Re: El Segundo Power Plant Project (00-AFC-14C)
Applicant's Letter dated May 24, 2013
to South Coast Air Quality Management District

Subject: El Segundo Power Facility Modification Project – SCAQMD Permit
Application

The following are responses to requests for additional clarifying information contained in May 11, 2013 emails from you to George Piantka regarding the March 2013 permit application for the proposed El Segundo Power Facility Modification Project.

Figure 1

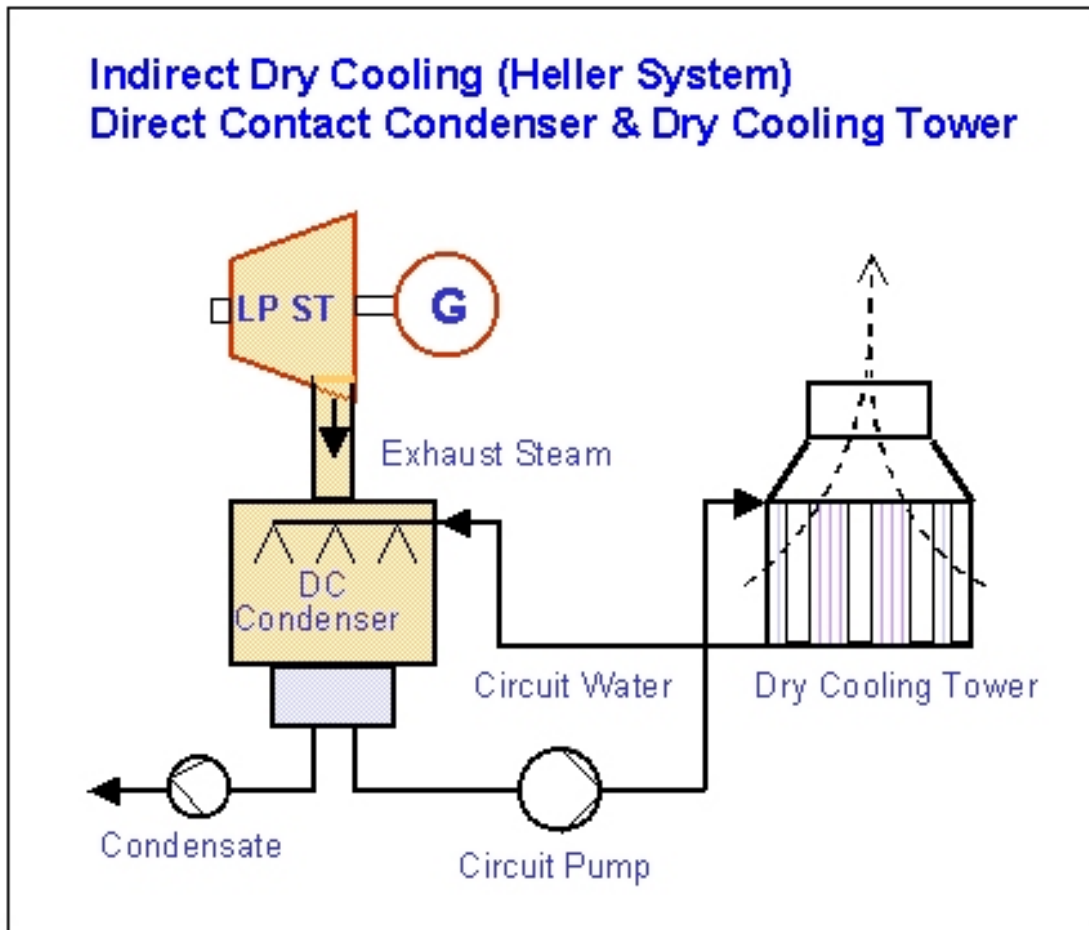
Request: The process flow diagram indicates there will be new cooling towers proposed for the ESPFM.

Response: The cooling structures shown on the drawing utilize dry cooling. There are no particulate emissions from the cooling system.

Cooling for the combined cycle unit will be provided by a Heller system. A Heller system is an indirect dry cooling system that uses air as a secondary cooling medium. The primary cooling medium is cooled condensate returned from the dry tower, but the condensate flows in a closed system and is never in contact with the cooling air.

Exhaust steam from the steam turbine is condensed by direct contact with cooled condensate. Water from the direct contact jet condenser is divided into two streams. One water stream, equal to the amount of condensate from the steam cycle, is pumped forward to be heated again in the HRSG. The other water stream, which is most of the water, is pumped to a dry cooling tower, where it is cooled in non-evaporative water-to-air heat exchangers. The cooled water is then returned to the condenser where it is sprayed into and mixed with the exhaust steam. The steam condenses on the surface of the droplets and collects in the hotwell.

An illustrative schematic is provided below in Figure 1.
